Date: June 17, 2014
To: Dave Schechinger, V-K Engineering
Greg Parker, Johnson County Engineer
From: Kris Ackerson, Assistant Transportation Planner
Brad Neumann, Assistant Transportation Planner
Re: The Meadows Subdivision traffic impact analysis

Per your request, the following memorandum provides our assessment of the potential traffic impacts related to The Meadows Subdivision in West Branch.

Figure 1: Traffic volume and speed data (April 22-25, 2014)

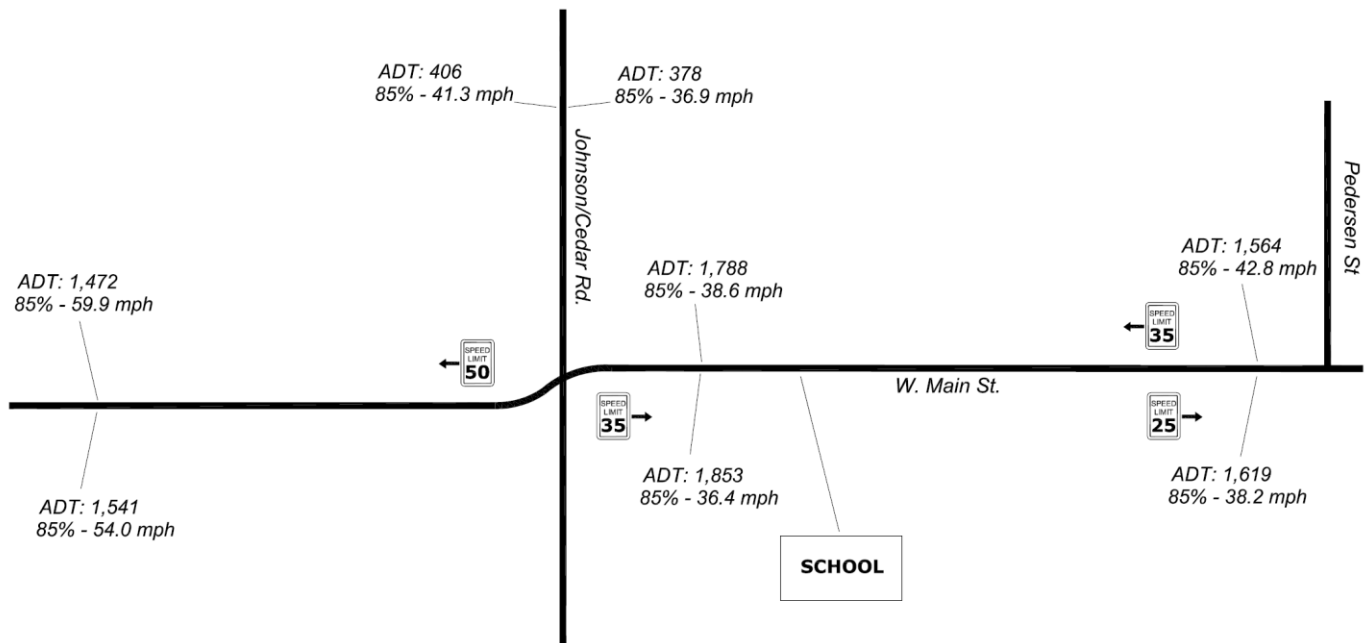
The 85th percentile speeds on West Main Street in the 50 mph zone were recorded at 55 mph in the westbound lane and 54 mph in the eastbound lane. The 85th percentile speeds in the 35 mph speed zone (in front of the high school) were 36-37 mph. The 85th percentile speeds in the 25 mph speed zone were 38-42 mph. The 85th percentile speeds on northbound Johnson Cedar Road were 36 mph (ADT/speed summary pages are attached).

The 85th percentile speeds in our study indicate that the current posted speeds are appropriately set except the 25 mph zone where the high speeds are likely due to the open, mostly undeveloped (fewer access points) nature of the area. Although the area is predominantly residential, the houses are set back similar to a more rural setting allowing for good sight distance. We recommend leaving the posted speed limits at their current levels and moving the 35 mph speed zone further east to Scott Drive. The data indicates that drivers are generally comfortable driving faster than 25 mph. Alternatively, increased enforcement should be considered if the speed limit remains at 25 mph. Radar feedback speed signs could also be considered in the 25 mph posted zone.

Figure 2: Morning peak hour westbound left turn lane warrant at Dawson/Main St/School

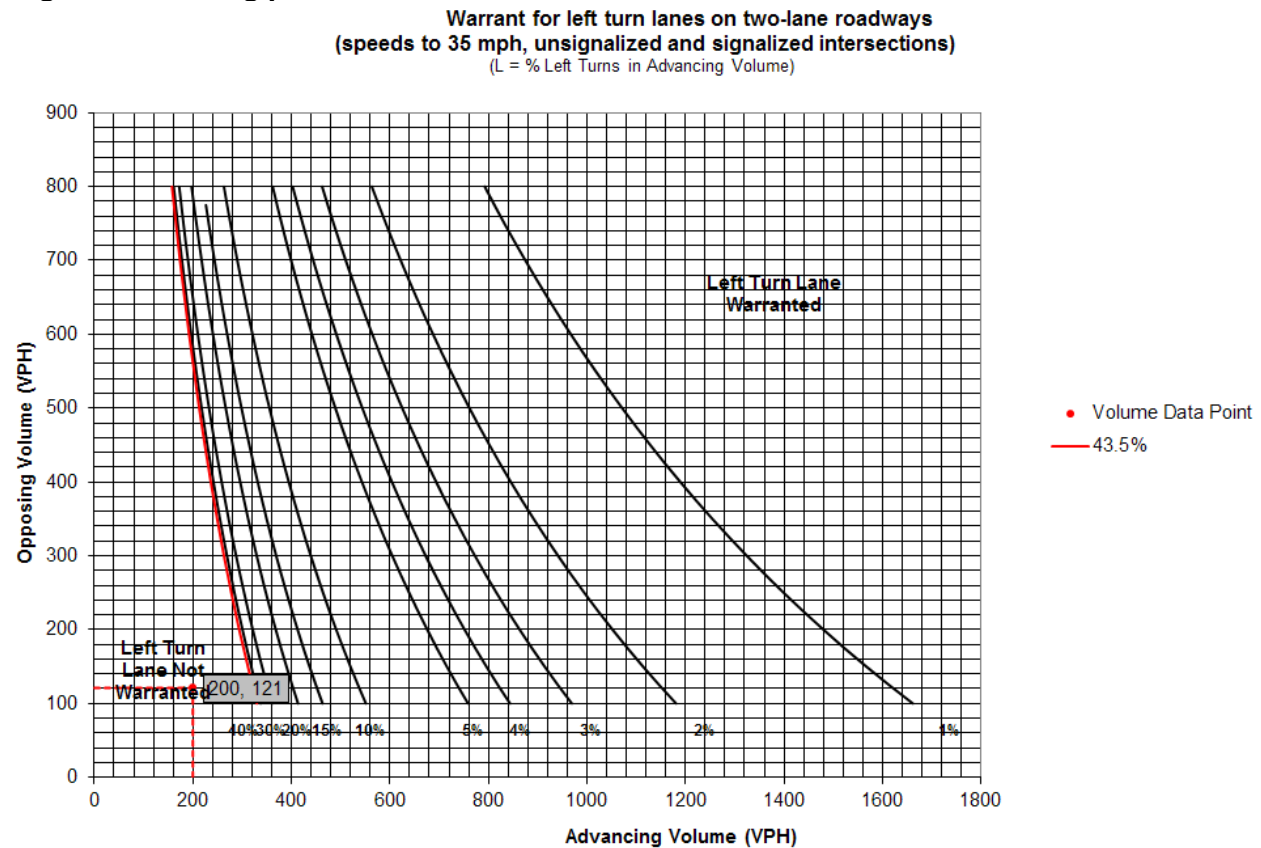
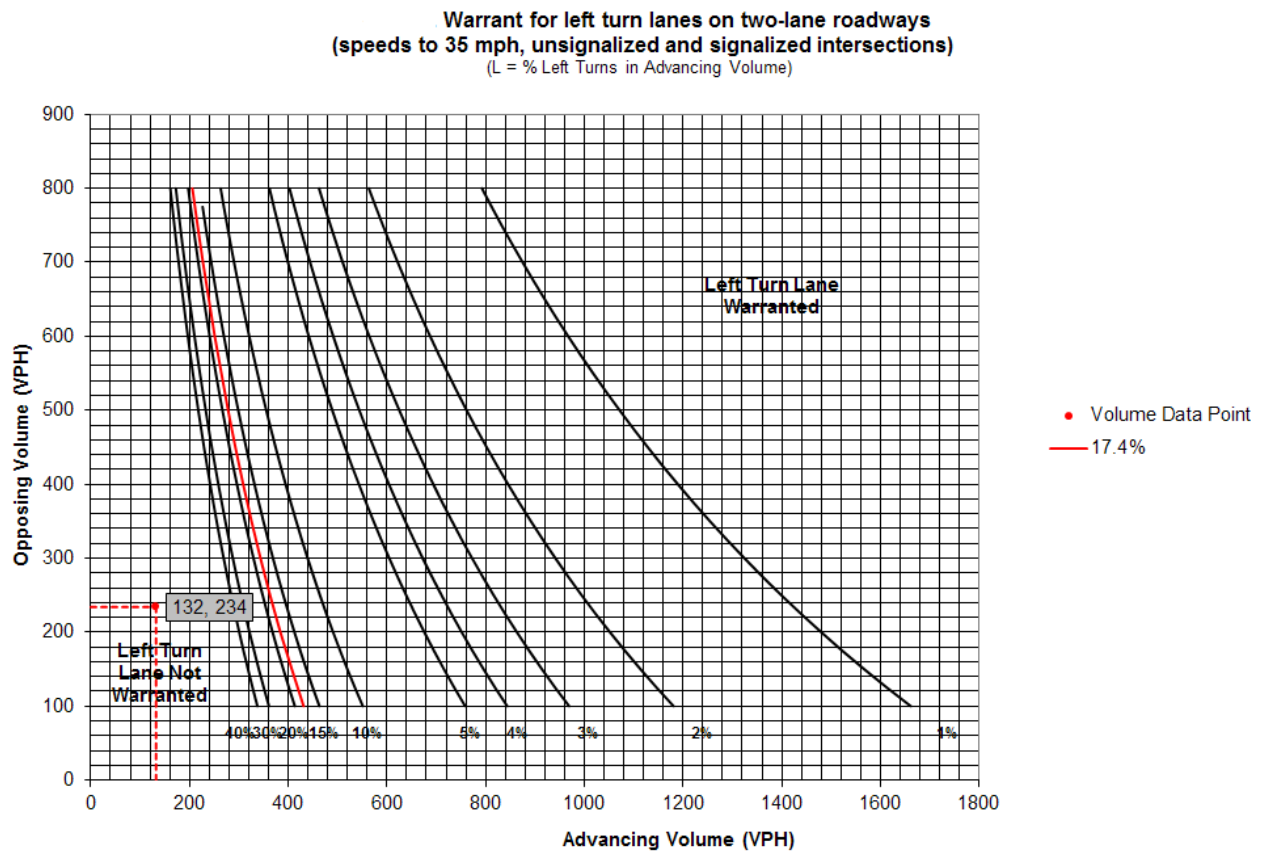
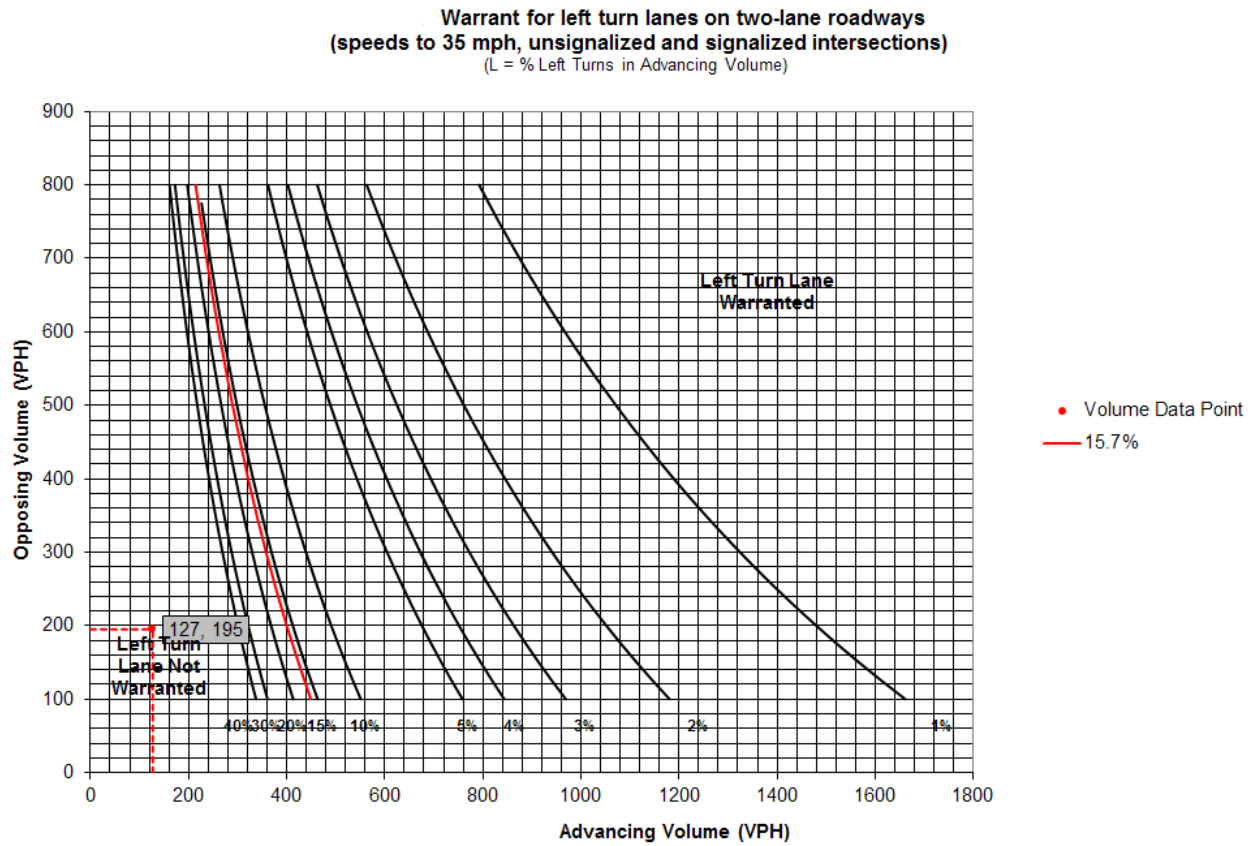
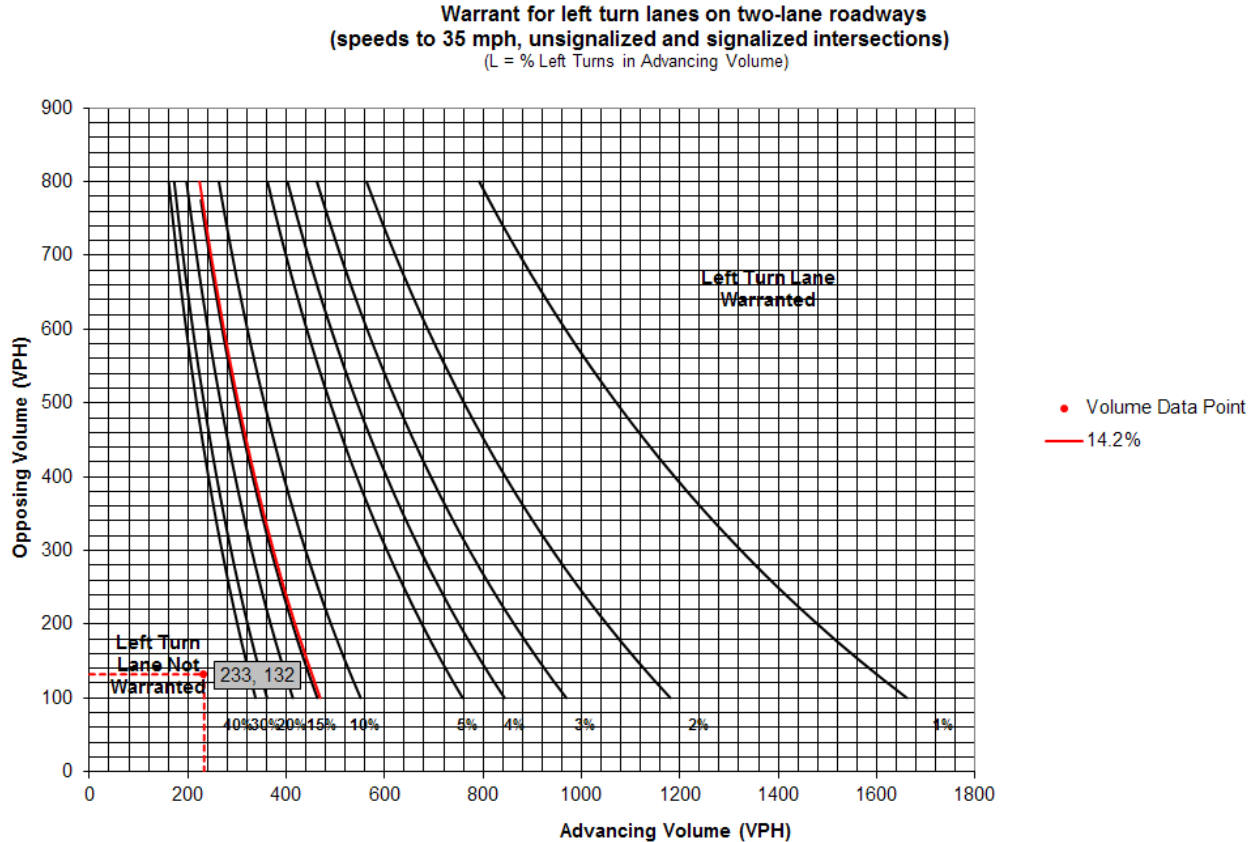
Based on projected volumes and the assumption that Dawson Drive and the new school access will meet at the same point on Main Street, turn lanes will not be warranted when The Meadows Subdivision is built-out and the middle school and high school are joined (Figures 2-5). However, as development north and east of The Meadows Subdivision continues the need for additional infrastructure (e.g. turn lanes, roundabouts, curb and gutter) on Main Street may arise.

Figure 6: Morning peak hour eastbound left turn warrant at Main St/Johnson Cedar Road

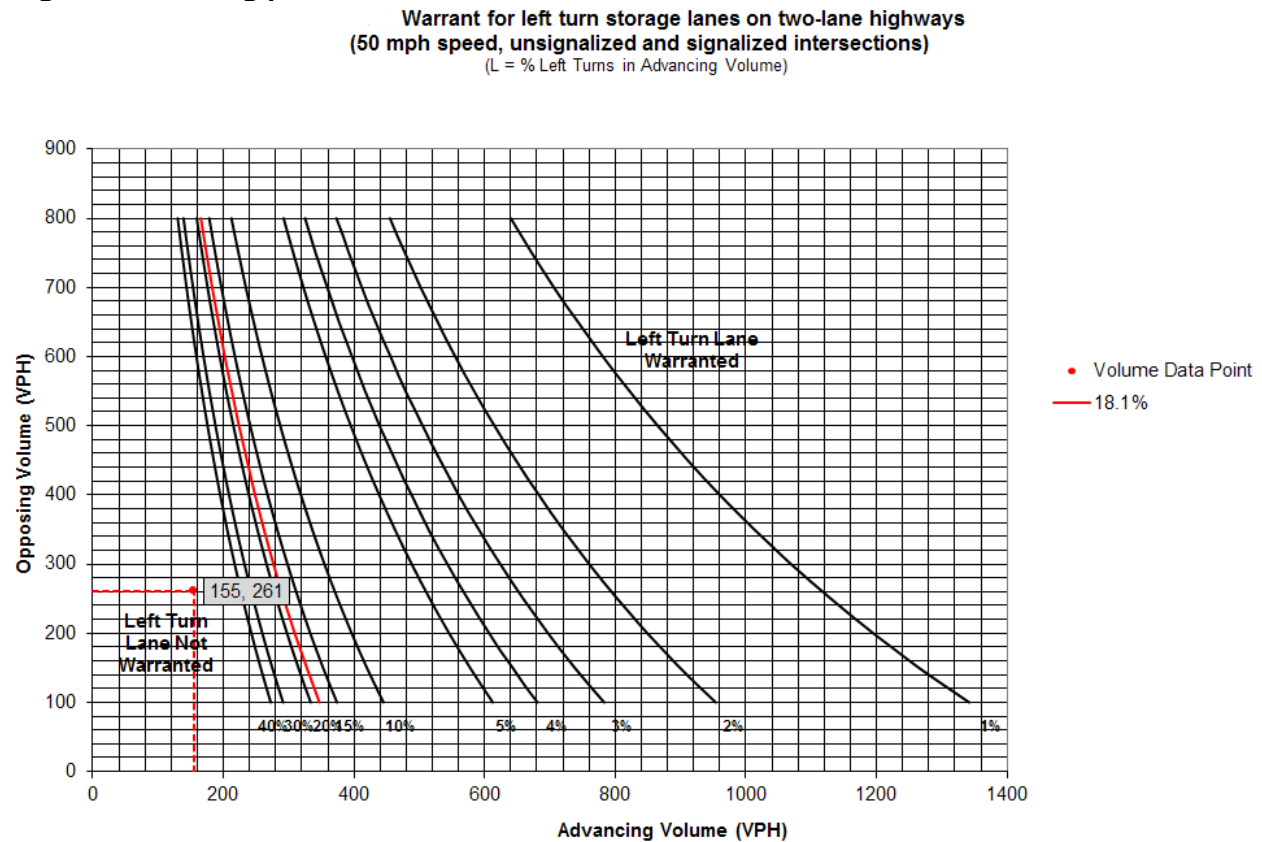
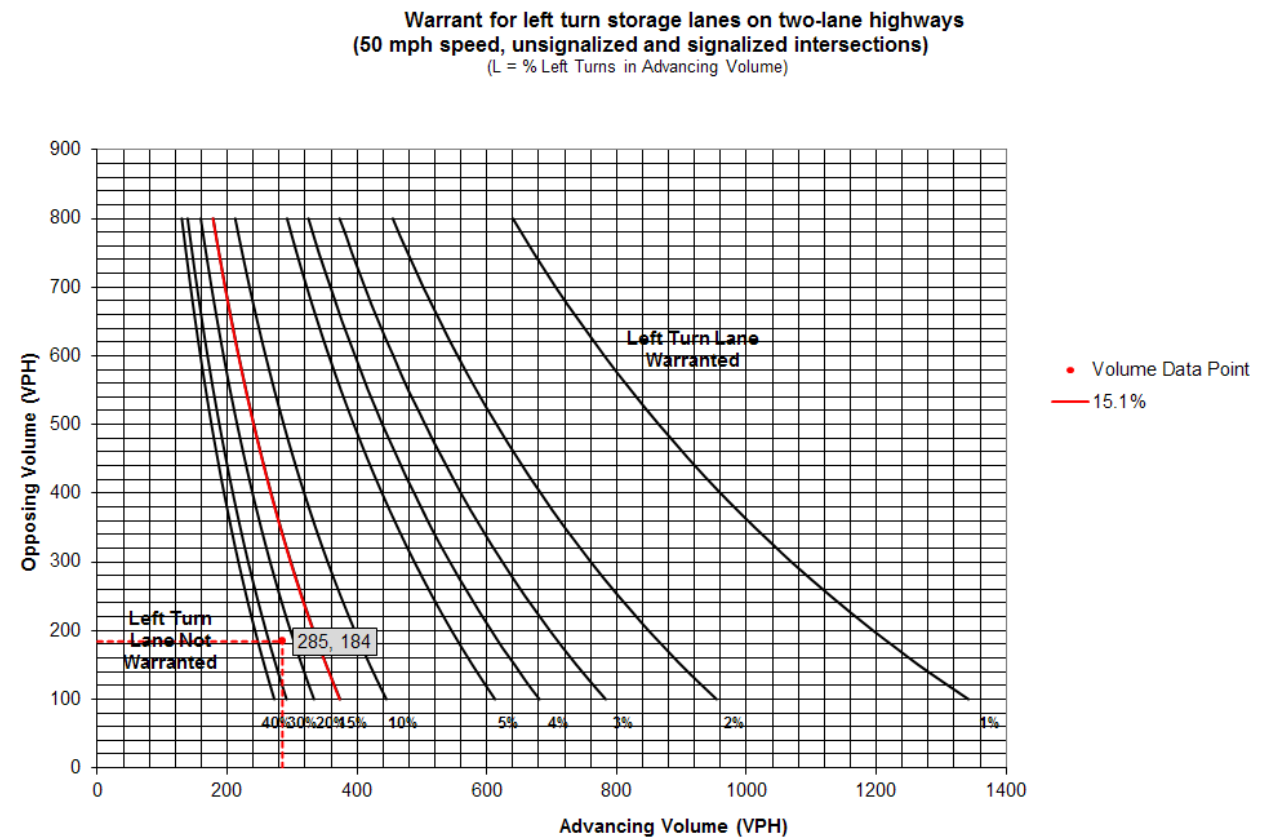
Based on peak hour traffic counts (Tables 3 and 4) and the projected traffic volumes generated by The Meadows Subdivision, a left-turn lane is not warranted for eastbound traffic during the morning peak hour (Figure 5). The afternoon peak hour calculation indicates an eastbound left turn is also not warranted (Figure 6), but two additional factors should be considered. First, the intersection has limited sight distance for eastbound vehicles approaching the intersection, which could lead to an increase in rear-end collisions as the volume of left-turning (east- to northbound) traffic increases. Additionally, if the *actual* volume of left-turning traffic during the PM peak hour is eighteen or more cars higher than *projected* in this report due to adjacent development, then a left-turn lane will be warranted. As a result, staff recommends that the City install a left-turn lane for eastbound vehicles when Gilbert Drive and Orange Street are connected to Johnson Cedar Road, at which time Johnson Cedar Road should also be reconstructed.

- Staff recommends that the City install a left-turn lane for eastbound vehicles when Gilbert Drive and Orange Street are connected to Johnson Cedar Road, at which time Johnson Cedar Road should also be reconstructed.

LOT LAYOUT EXHIBIT THE MEADOWS SUBDIVISION WEST BRANCH, IOWA

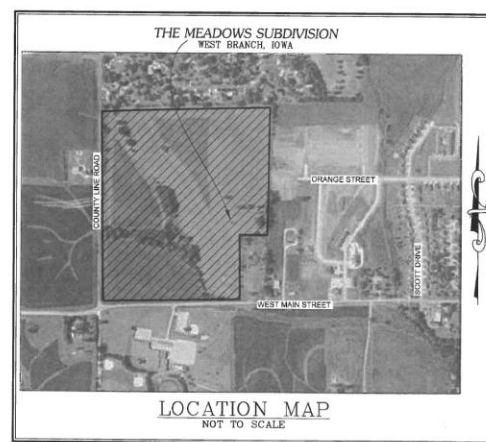
Based on the plat of The Meadows Subdivision, 151 dwelling units are proposed. As proposed, the development includes three access points to neighboring properties; one to the east, one access point on Main Street (south), and two on Johnson Cedar Road (west).

- Align Dawson Drive with the new school entrance to create a four-leg intersection, which will improve traffic circulation.
- Consider requesting a detailed analysis from the school district evaluating the pros and cons of separated entrance and exit points from the school property to improve circulation, reduce queuing, and prevent turning conflicts from motorists entering the school driveway from the east at the same time motorists are attempting to turn left (toward employment centers) out of the school exit.
- Install a signed and painted crosswalk at this new four-way intersection. Consider LED crosswalk warning system and proper signage.
- Connect existing trail along the south side of West Main Street to this intersection.
